Re: Response to NMED Comments of January 3, 1997 to December 9, 1996  
Sparton Proposal

**Aquifer Testing/Extraction Demonstration/ Additions to Monitoring  
Network**

**Coors Road Facility  
Sparton Technology, Inc.  
Albuquerque, New Mexico**

**Vapor Extraction System Pilot Testing  
Coors Road Facility  
Sparton Technology, Inc.  
Albuquerque, New Mexico**

**FIGURE 1**  
 RECOVERY WELL AND MONITORING NETWORK

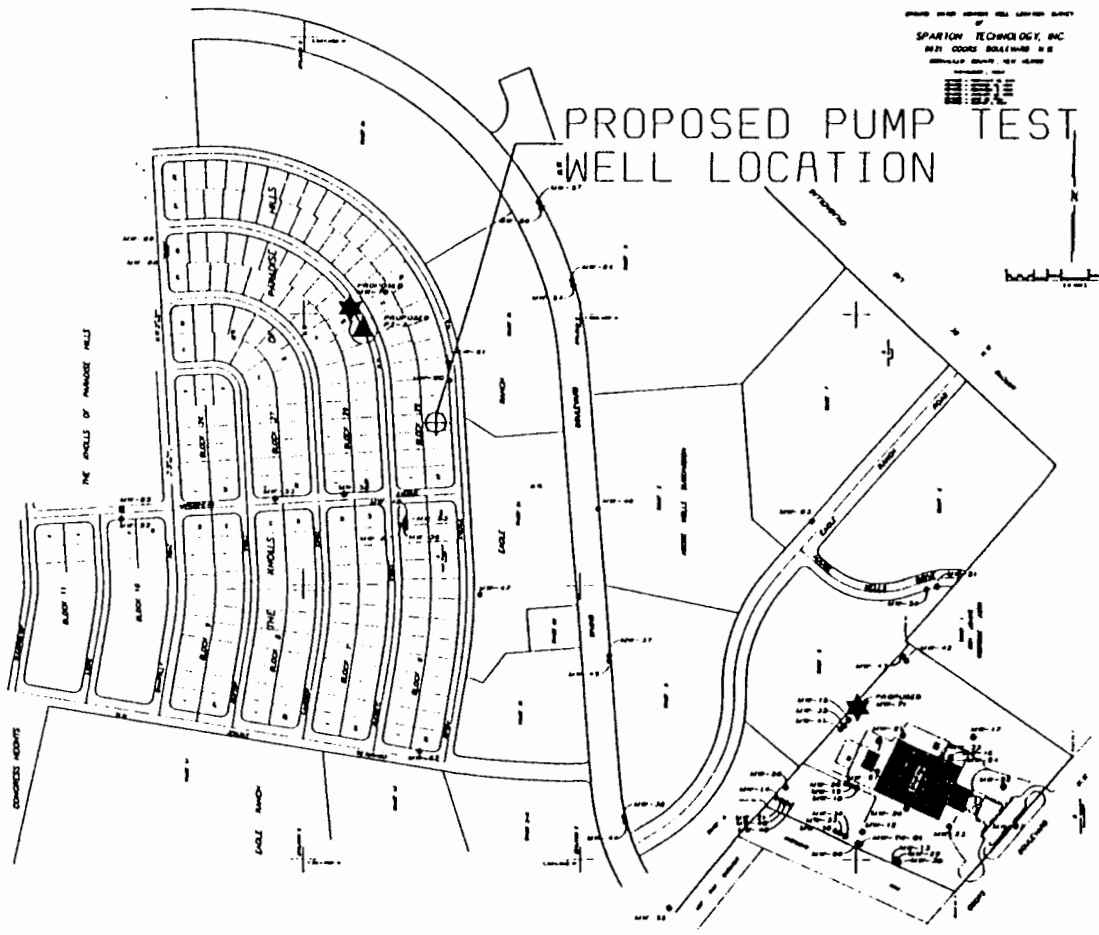
2. In the September 26-27, 1996, meetings, NMED initially had requested a minimum of four additional monitoring wells located along what Dennis McQuillan described as a "keel." The requested wells were located as follows:
  - a. A non-detect well below existing cluster MW-15, MW-32, and MW-41;
  - b. A non-detect well below existing well MW-46; and
  - c. A new two-well cluster on Buckeye Street northwest of existing cluster MW-60 and MW-61.

- a. A new no-detect well to the existing cluster MW-15, MW-32, and MW-41, (MW-71).
- b. A new piezometer/well cluster on Buckeye Street northwest of the proposed pump test location and approximately on the "keel." The new well would be installed as a non-detect well. Based on the completion depth of the well, a piezometer would be installed either above or below the well screened interval to provide water level data in the entire zone (depth) impacted by the pump test well (MW-70).
- c. A pump test well would also serve as another non-detect well, that initially would be installed across the entire plume vertical interval to provide additional definition of the bottom of the plume along the "keel," in lieu of the new deep monitoring well at the existing well MW-46 location (Pump Test Well).

Your letter suggests something other than what we agreed to. In particular, we understand you are now asking for either multiple wells or a multiple completion well in the vicinity of the location of our proposed MW-70, and a separate piezometer distant from whatever monitor well is installed. We continue to believe what we proposed and you accepted is sufficient for purposes of defining the "keel," and analyzing the effectiveness of the pump test well.

An additional groundwater monitoring well, MW-70, clustered with separate piezometer, PZ-2, will be installed in the public right-of-way along Buckeye Street northwest of the pump test well location and existing cluster 10 (MW-60/MW-61). This new piezometer/well cluster would be located as shown on Figure 1.

The new well, MW-70, will be installed as a non-detect well to define the vertical limit of the plume. Temporary casing will be installed during drilling to allow sampling/analysis verification of plume limits prior to well installation. The vertical plume limits at MW-70 will be compared to the vertical plume limits at the previously installed pump test well. Anticipating MW-70 will be completed to a higher excavation than the bottom of the pump test well, the piezometer will be installed deeper to the same approximate bottom elevation as the pump test well. However, if MW-70 extends to approximately the same bottom elevation as the pump test well, then the piezometer would be installed in the uppermost portion of the aquifer. The purpose for the well/piezometer cluster is

**SPARTON TECHNOLOGY, INC.**  
 COORS ROAD FACILITY  
 VES - PILOT TEST

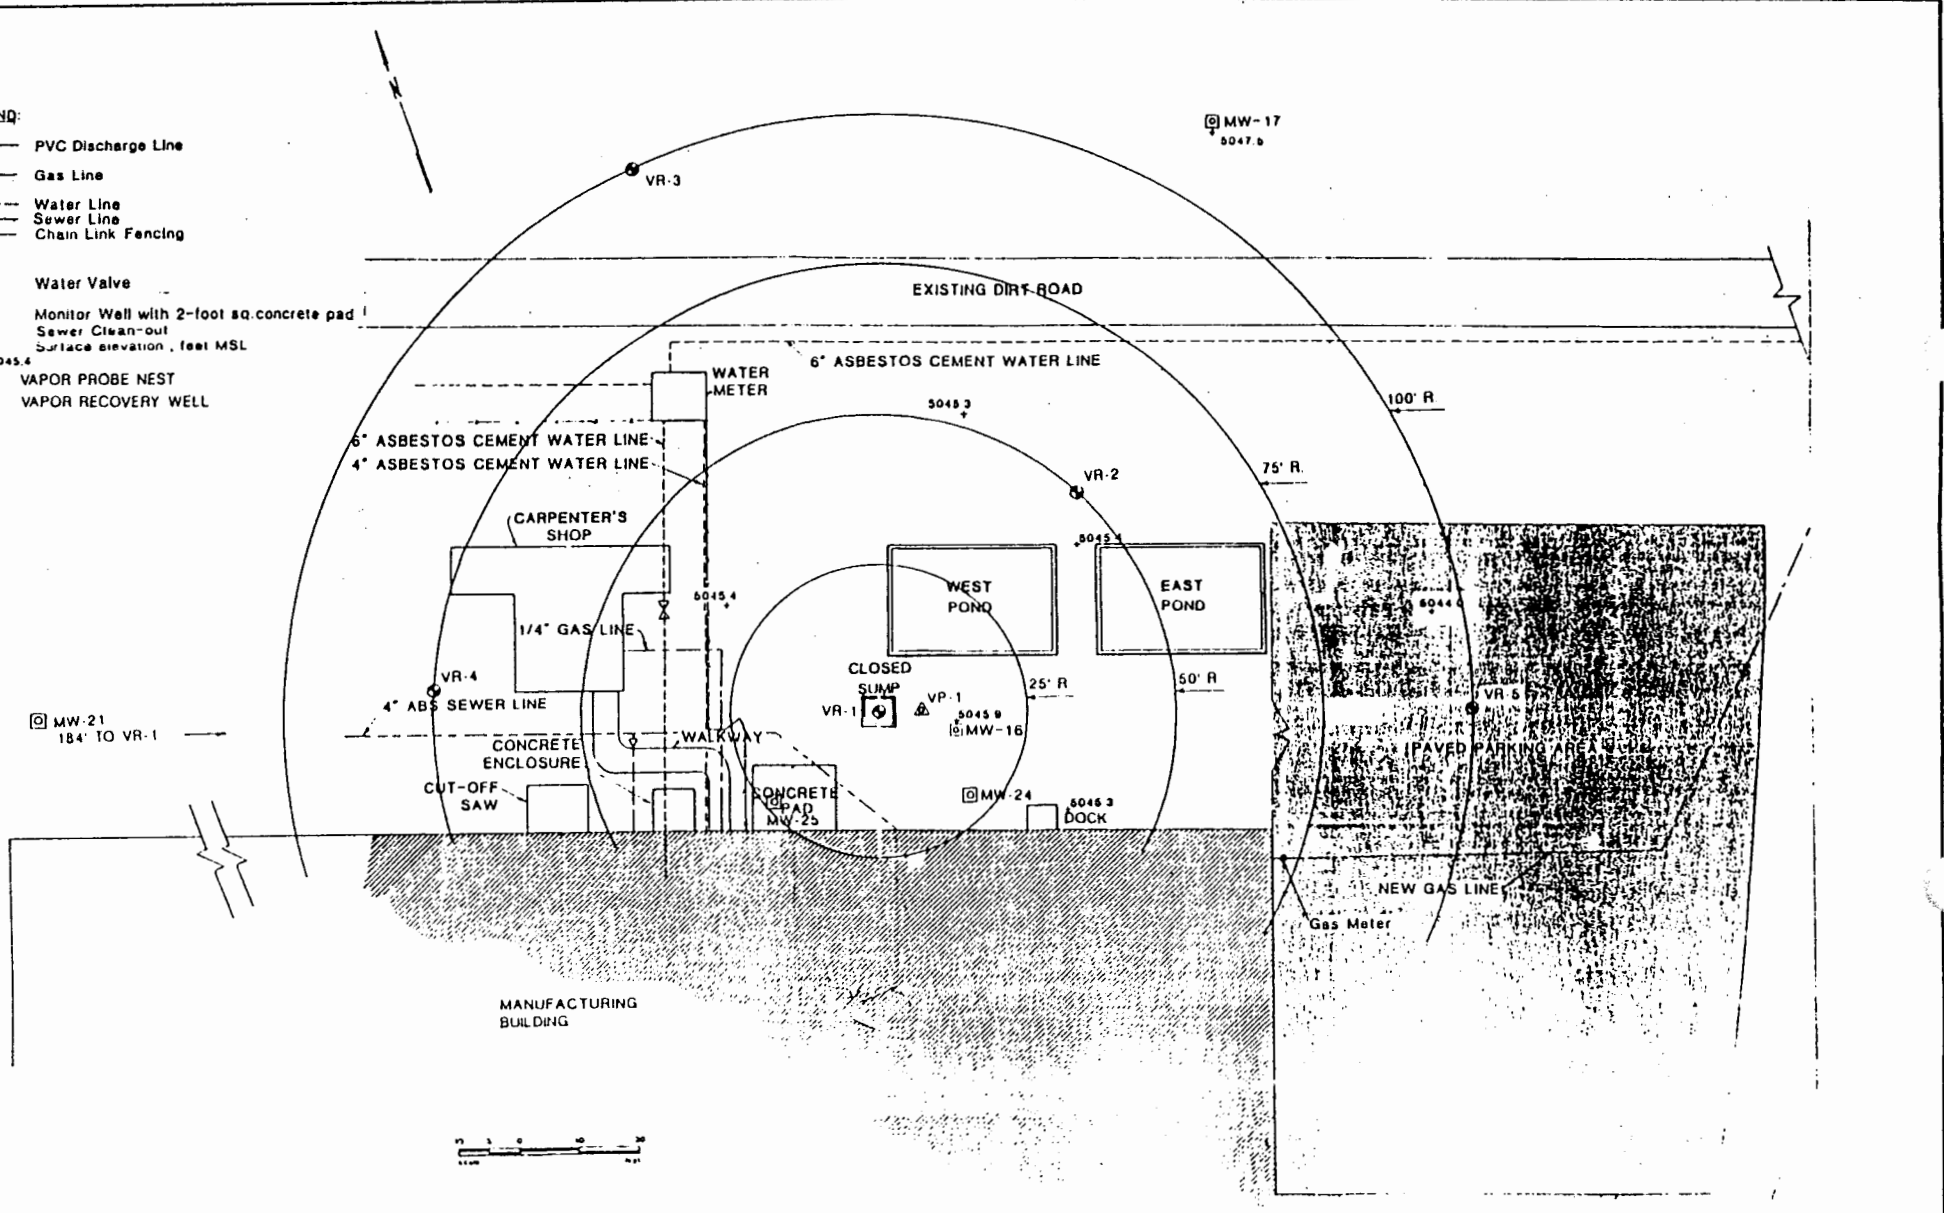
A drilling contractor has been scheduled to begin installation of soil vapor recovery wells VR-1 through VR-5 the first week of February 1997.

The pilot test is proposed to define the relationship between VOC concentrations and extraction vacuum and extraction flow rates from a recovery well located directly under the sump area (see Figure 1). Monitoring points (proposed and existing) are located at varying horizontal distances and depths to allow evaluation of effective influence of the centrally located recovery well.

The pilot test is proposed to be conducted using the central four-inch recovery well (VR-1). The remaining recovery wells (VR-2 through VR-5), UFZ groundwater monitoring wells (MW-17, MW-21, MW-24, and MW-25), and vapor probe cluster

(VP-1) would be used as observation points for the pilot testing (see Figure 1). The pilot testing will be conducted at several different rates of vacuum and flow (up to the maximum capability of the extraction unit) to determine the performance characteristics of the vapor recovery well/adjacent subsurface.
